May 14, 2007
NRC-07-0009

Subject: Submittal of Proposed Revision to the Fermi 2 Radiological Emergency Response Preparedness Plan (RERP Plan)

**PROPOSED CHANGES
AND
JUSTIFICATION FOR
FERMI 2 RERP PLAN REVISION**

ELECTRONIC MARK-UPS
OF PROPOSED CHANGES TO
FERMI 2 RERP PLAN

Figure B-2
CONTROL ROOM

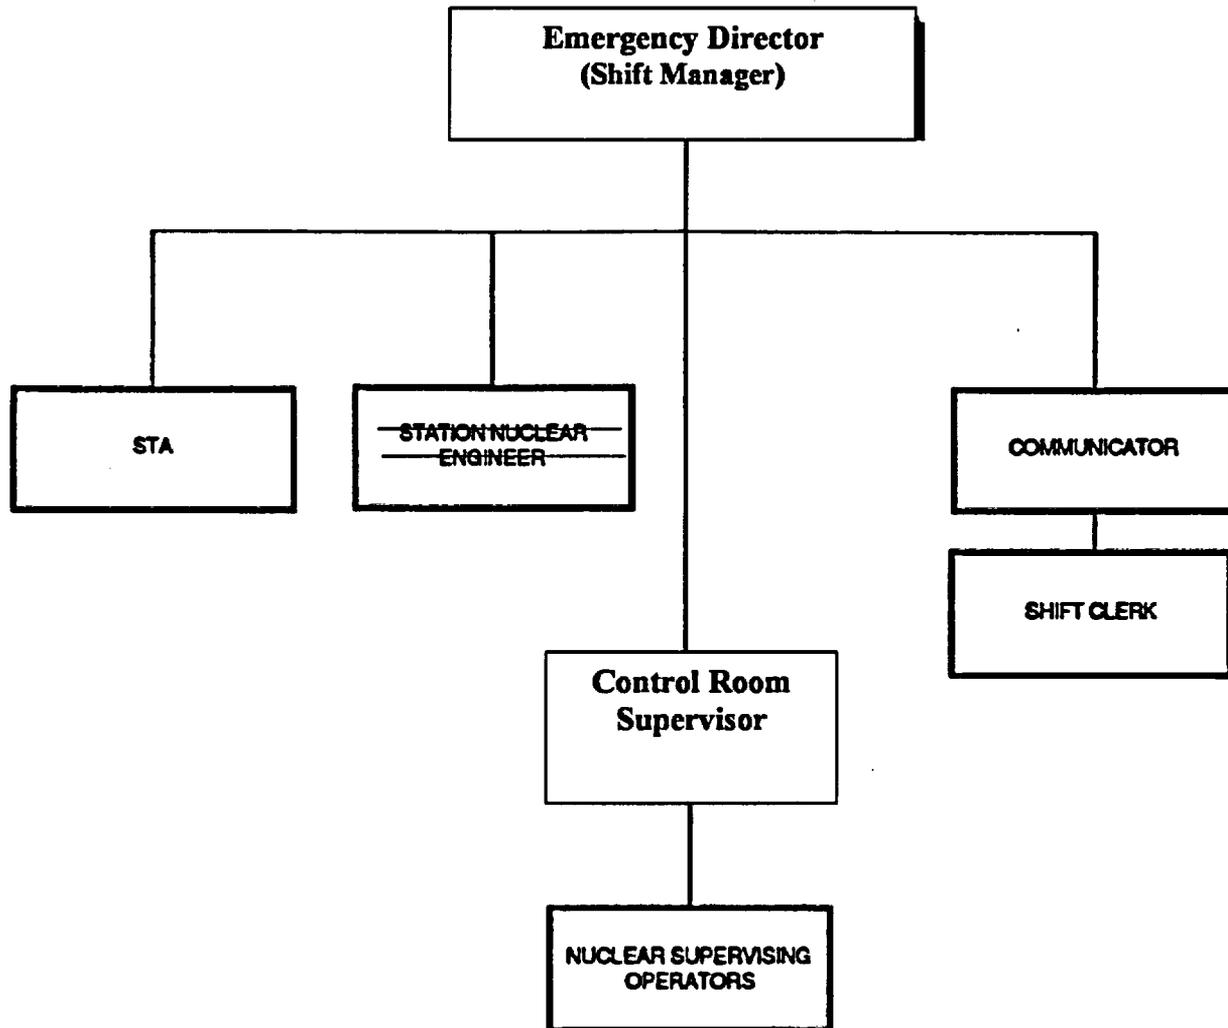
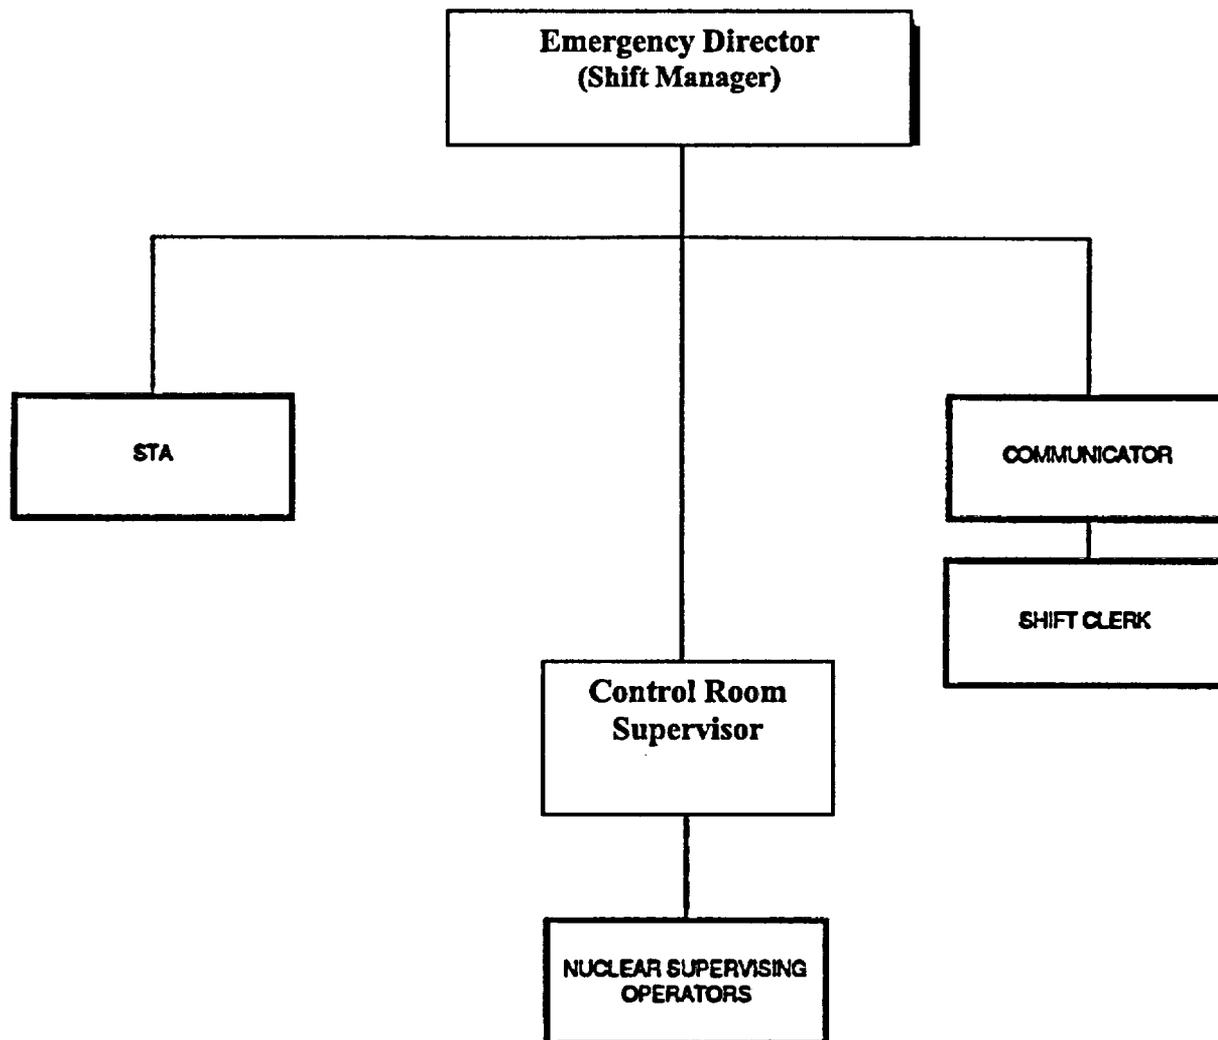
Proposal 1- Delete the requirement for Station Nuclear Engineer (SNE) (RERP Plan Revision 32) or Reactor Engineer (RERP Plan revision 3A) from reporting to the site in 30 minutes.

Revision 32 - Table B-1, pg. B-3 and Table B-2, pg. B-5, Figure B-2, pg. B-16
Revision 3A – Table B-1, pg. B-8, Table B-2, pg. B-11, Figure B-3 (no page number identified)

The proposed change does not negate the task of technical support. It is retained by a qualified person on-shift, the STA, until relieved by another qualified person, in the TSC. The change as written is considered an alternative for meeting the regulations and staffing guidelines as indicated in NUREG-0654, Table B-1.

Figure B-4

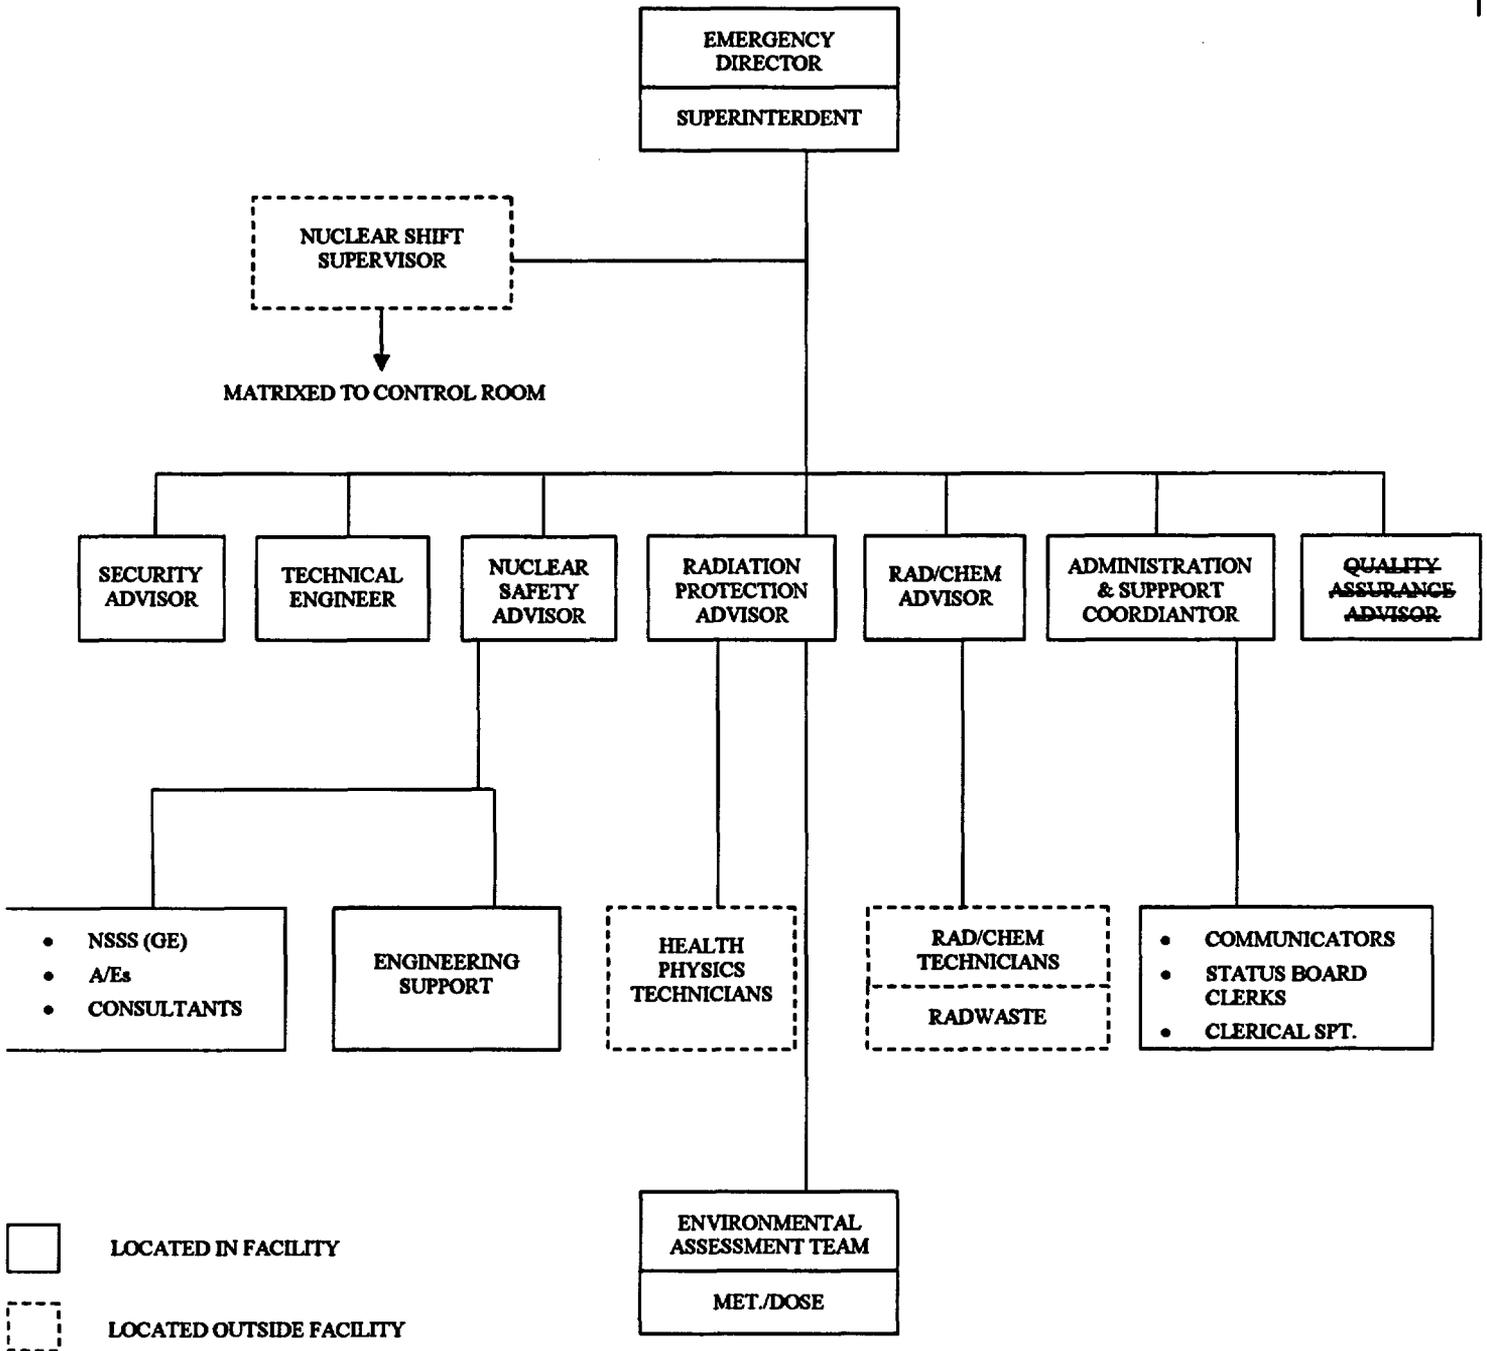
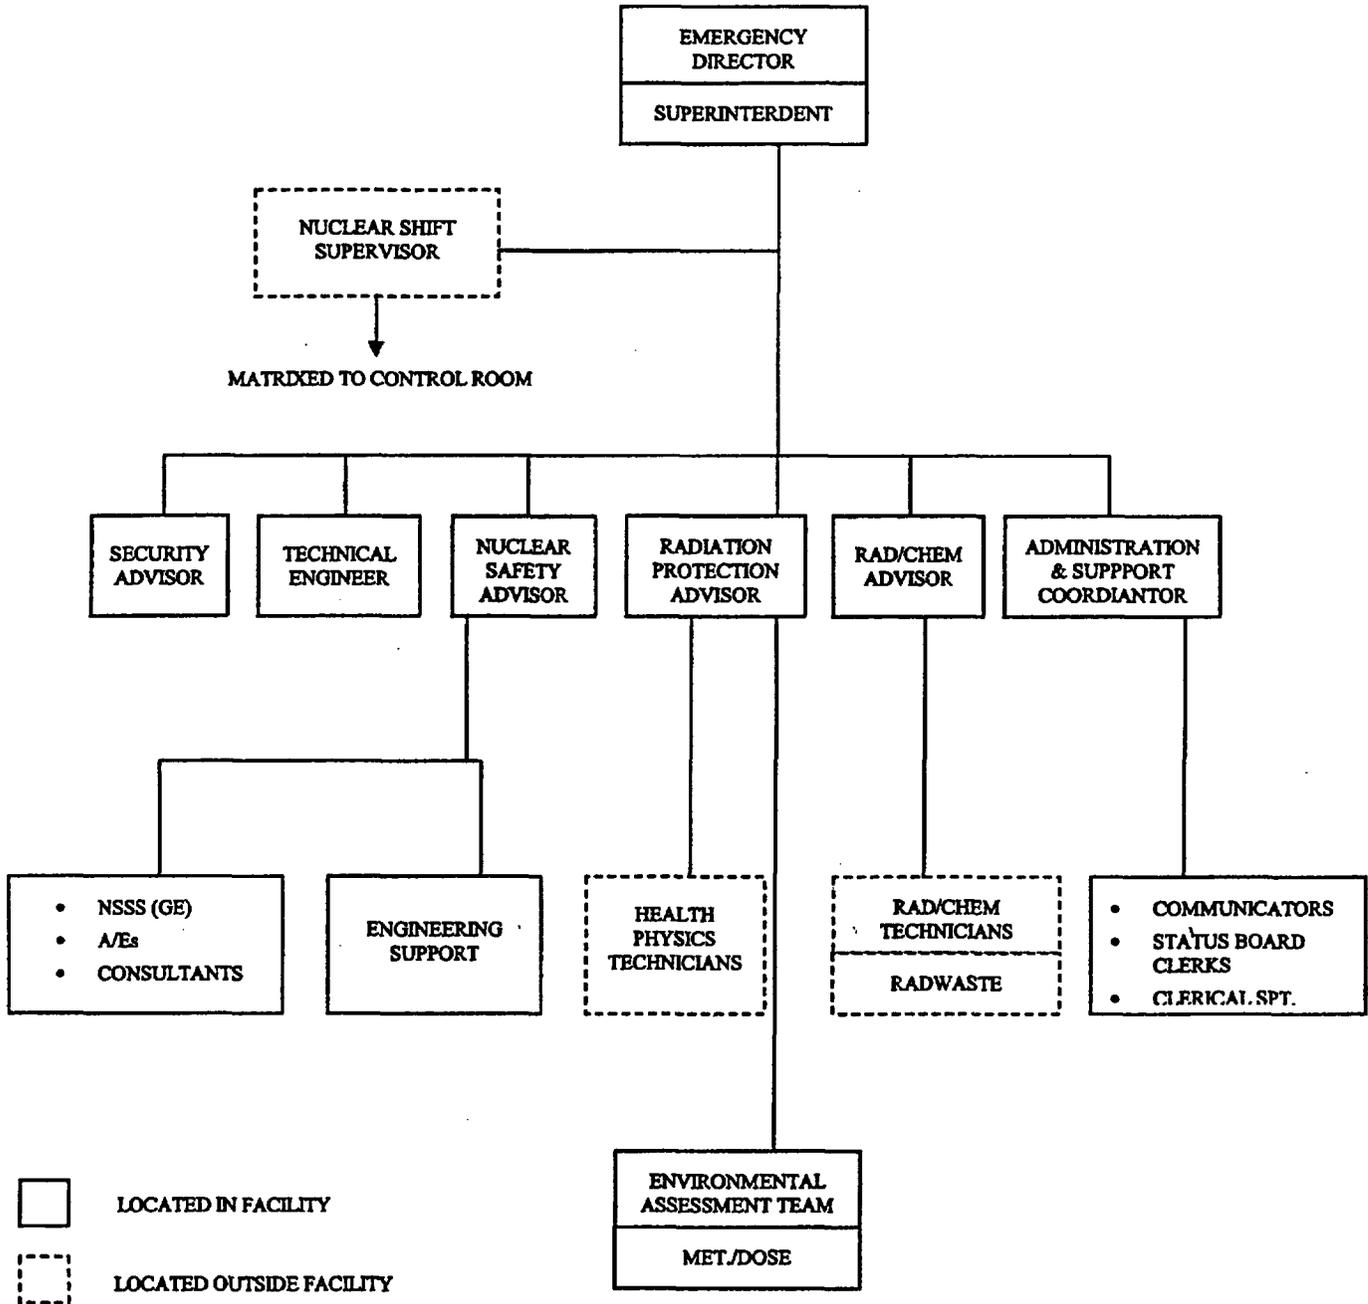
Delete the Quality Assurance (QA) Advisor position.

Revision 3A - Table B-2, pg. B-16, Figures B-4 and B-5 (no page numbers identified)

Therefore the QA Advisor position is not needed for the initial response of an emergency. The Manager - NQA as part of the Recovery Organization and as such will ensure the QA requirements are met. The function has been maintained, therefore, there is no decrease in effectiveness as a result of this change.
